APPLICATION NO.	FILING DATE	FIRST NAMED INVENTOR	ATTORNEY DOCKET NO.	CONFIRMATION NO.
10/581,328	06/01/2006	Georg Muhlthaler	WUE-60	3182
Thomas J Burge	7590 04/30/200 er	EXAMINER		
Wood Herron & Evans 2700 Carew Tower 441 Vine Street Cincinnati, OH 45202-2917			GREEN, RICHARD R	
			ART UNIT	PAPER NUMBER
			4174	
			MAIL DATE	DELIVERY MODE
			04/30/2008	PAPER

DETAILED ACTION

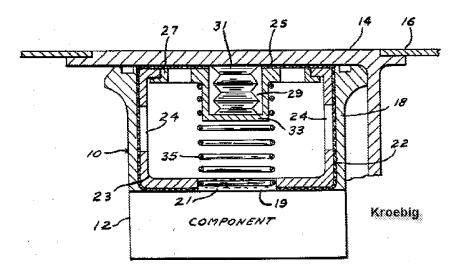
Claims 1-6 and 13-18 are rejected under 35 U.S.C. 102(b) as being anticipated by US-4000776 to Kroebig et al. (hereafter Kroebig).

Claim 1: Kroebig teaches a cooling device for expelling heat from a heat source located in the interior of an aircraft ("component 12," col. 1, line 49) to a heat sink ("missile skin 16," col. 1, line 51), with a piping system ("heat pipe 10," col. 1, line 49) sealed against the surrounding atmosphere (it is considered to be), which is thermally coupled to a heat intake section ("evaporator section 19," col. 1, line 57) with the heat source and to a heat output section ("the heat pipe cover ... acts as the condenser," col. 2, lines 11-13) with the heat sink (col. 1, line 51- col. 2, line 10), and which preferably has an essentially adiabatic conveyance section ("wick 22," col. 1, line 55), whereby the piping system is filled with a heat conveyance medium ("liquid 21," col. 1, line 54) which, when it takes in heat from the heat source in the heat intake section undergoes a transition from the liquid phase to the gaseous phase, then flows into the heat output section and here, when discharging heat to the heat sink, condenses once again and flows back into the heat intake section ("as the component temperature increases, it

Claim 2: Kroebig teaches a cooling system in accordance with claim 1, whereby the piping system includes a closed pipe ("heat pipe 10," col. 1, line 49), of which one end section is the heat intake section and of which the other end section is the heat output section, whereby both end sections are connected to one another via the conveyance section (see figure).

Claim 3: Kroebig teaches a cooling system in accordance with claim 1, whereby the heat source includes at least one component of an electronic device in the aircraft (component 12, figure), an on-board kitchen in the aircraft, a surface requiring cooling in the aircraft, or similar.

Claim 4: Kroebig teaches a cooling system in accordance with claim 1, whereby the heat sink includes a section of an external wall of the aircraft ("cover 14 which forms part of the missile skin 16," col. 1, line 51; figure), an aircraft structure, an aircraft bilge, an air channel, in particular a ram air channel, or a heat exchanger.

Claim 13: Kroebig teaches a cooling system in accordance with claim 1, whereby a cold storage unit (chamber 29, col. 2, line 3; figure) is provided between the heating source and the heat sink. The camber 29, is taught to store a bellows containing "a gas such as air," (col. 2, line 6) and is considered to comprise a cold storage unit, especially since the relative cool temperature of the gas contained within the bellows 31 is critical to the functioning of the cooling system taught by Kroebig.

Claim 14: Kroebig teaches cooling system in accordance with claim 1, whereby a cold storage unit is provided in the section of the heat source. The chamber 29 is considered a cold storage unit as described in the rejection to claim 13, and as it is taught to be provided in the interior of the missile as shown in the sole figure, it is considered to be provided in the section of the heat source.

sink by means of a feed line (heat pipe 10) and a discharge line (wick 22) respectively (see figure).

Claim 16: Kroebig teaches a cooling system in accordance with claim 13, whereby the cold storage unit (chamber 29) is located in a special circuit (the chamber is considered to be in a reaction circuit comprising bellows 31 and spring 35) with a special piping system (bellows 31 contain air or "a heat expandable fluid," [col. 2, line 7] and are considered a special piping system).

Claim 18: Kroebig teaches a method for the discharge of heat from a heat source (component 12, figure) located in the interior of an aircraft (a missile) to a heat sink (missile skin 16, figure), whereby a piping system sealed against the surrounding atmosphere (heat pipe 10, figure), which is thermally coupled to a heat intake section ("evaporator section 19," col. 1, line 57) with the heat source and is thermally coupled to a heat output section ("the heat pipe cover ... acts as the condenser," col. 2, lines 11-13) with the heat sink (col. 1, line 51- col. 2, line 10), and which preferably has an essentially adiabatic conveyance section ("wick 22," col. 1, line 55), is filled with a heat

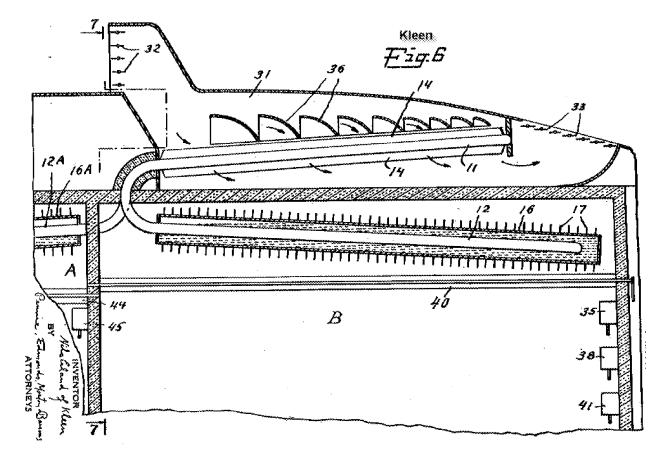
Claims 1-7 and 10-18 are rejected under 35 U.S.C. 102(b) as being anticipated by US-2499736 to Kleen.

Claim 2: Kleen teaches a cooling system in accordance with claim 1, whereby the piping system includes a closed pipe ("closed circuit or tube," col. 1, lines 48-50), of which one end section is the heat intake section (fig. 6, item 11) and of which the other end section is the heat output section (fig. 6, item 12), whereby both end sections are connected to one another via the conveyance section (fig. 6, visible bend in pipe).

The heat sink taught by Kleen in flight is ambient outside air conveyed through a duct (col. 7, lines 57-60), and figure 6 displays an air channel defined by intake 32 and outlet 33.

Claim 5: Kleen teaches a cooling system in accordance with claim 1, whereby the heat transfer in the heat intake section (fig. 6, vaporizing zone 12) and/or in the heat output section (fig. 6, liquefying zone 11) takes place by means of a heat exchanger which couples the heat source (fig. 6, cargo space B) and the heat sink (ambient air from inlet at 32) with the piping system (fig. 6, pipe continuous through 11, 13 and 12; "closed circuit or tube," col. 1, 48-50). Col. 2, lines 52-55: "The liquefying and vaporizing zones 11 and 12 are provided with extended heat transfer surfaces or fins 14 and 15, respectively," and fins 17 (fig. 6) are also described as heat transfer surfaces for vaporizing zone 12 in col. 3, lines 7-9.

Claim 10: Kleen teaches a cooling system in accordance with claim 1, whereby a temperature sensor (fig. 6, thermostat 38 or 41) is located in the section of the heat source (both 38 and 41 are in compartment B), whereby the cooling system is controlled with reference to the temperature recorded by the temperature sensor (both 38 and 41 are taught to control parts of the cooling system by the temperature recorded therein: 38 in col. 6, lines 54-72; 41 in col. 7, lines 17-32).

Claim 13: Kleen teaches a cooling system in accordance with claim 1, whereby a cold storage unit is provided between the heating source and the heat sink. Cold accumulator 16 is considered to act as a cold storage unit, and is located between the heating source and the heat sink, as visible in fig. 6.

Alternatively, if the heat source from claim 1 is considered to be compartment A (fig. 6), an analogous cooling system is taught for compartment A (col. 5, line 68-col. 6, line 3; fig. 6), and compartment B can be considered to form a cold storage unit provided between heating source A and the heat sink.

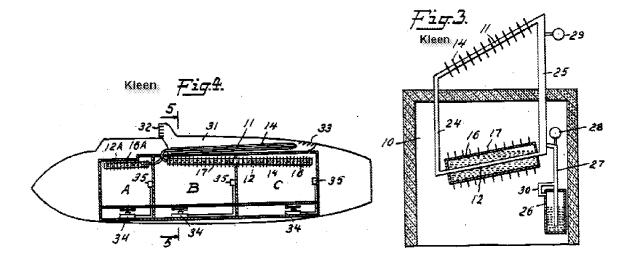
Claim 15: Kleen teaches a cooling system in accordance with claim 1, whereby the piping system forms a closed circuit (fig. 3) which connects the heat source and the heat sink by means of a feed line ("vapor tube 25" col. 5, line 10; fig. 3 and a discharge line ("liquid return tube 24" col. 5, line 7; fig. 3) respectively.

Claim 17: Kleen teaches a cooling system in accordance with claim 13, whereby when the aircraft is in rest condition, the heat sink is located geodetically higher than the cold storage unit and the heat source. This is visible in figures 4 and 6, when the heat sink is considered as the ambient air flowing through duct 31.

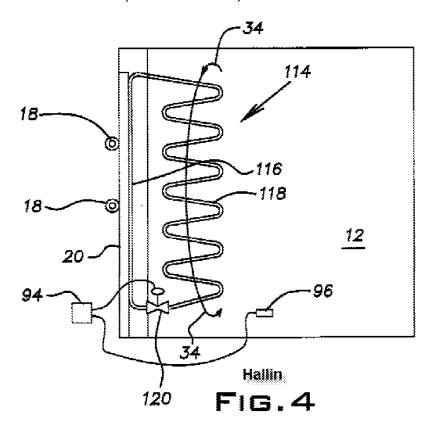
Claims 1, 8-12 and 15 are rejected under 35 U.S.C. 102(b) as being anticipated by US-5966951 to Hallin et al. (hereafter Hallin).

Claim 1: Hallin teaches a cooling device (fig. 4) which is considered capable of expelling heat from a heat source located in the interior of an aircraft to a heat sink, with a piping system (fig. 4, 114) sealed against the surrounding atmosphere, which is thermally coupled to a heat intake section (fig. 4, 118) with the heat source (fig. 4, 12) and to a heat output section (fig. 4, 116) with the heat sink (fig. 4, 20), and which preferably has an essentially adiabatic conveyance section (such as the top pipe near arrow 34), whereby the piping system is filled with a heat conveyance medium ("refrigerant vapor," col. 4, lines 21-22) which, when it takes in heat from the heat source in the heat intake section undergoes a transition from the liquid phase to the gaseous phase (col. 4, lines 28-31), then flows into the heat output section and here, when discharging heat to the heat sink, condenses once again and flows back into the heat intake section (col. 4, lines 38-45).

Claim 9: Hallin teaches cooling system in accordance with claim 8, whereby a regulator valve (fig. 4, 120) is assigned to the cooling system, by means of which the quantity of heat conveyance medium flowing to and/or from the heat exchanger is controlled (col. 6, lines 35-60 describe how the valve 120 controls the quantity of heat conveyance medium flowing to or from the heat exchanger).

Claim 10: Hallin teaches a cooling system in accordance with claim 1, whereby a temperature sensor (fig. 4, 96) is located in the section of the heat source, whereby the cooling system is controlled with reference to the temperature recorded by the temperature sensor (col. 6, lines 39-40, 46-60 describe how cooling system is controlled with reference to the temperature recorded by the temperature sensor).

Claim 12: Hallin teaches a cooling system, in accordance with claim 11, whereby a regulation device (fig. 4, controller 94) is provided, which controls the ventilator and/or the regulator valve (fig. 4, 120) in accordance with the temperature recorded by the temperature sensor (col. 6, lines 39-40).

Claim 15: Hallin teaches a cooling system in accordance with claim 1, whereby the piping system forms a closed circuit (fig. 4) which connects the heat source (fig. 4, 12) and the heat sink (fig. 4, 20) by means of a feed line (top half of pipe 114) and a discharge line (bottom half of pipe 114) respectively.
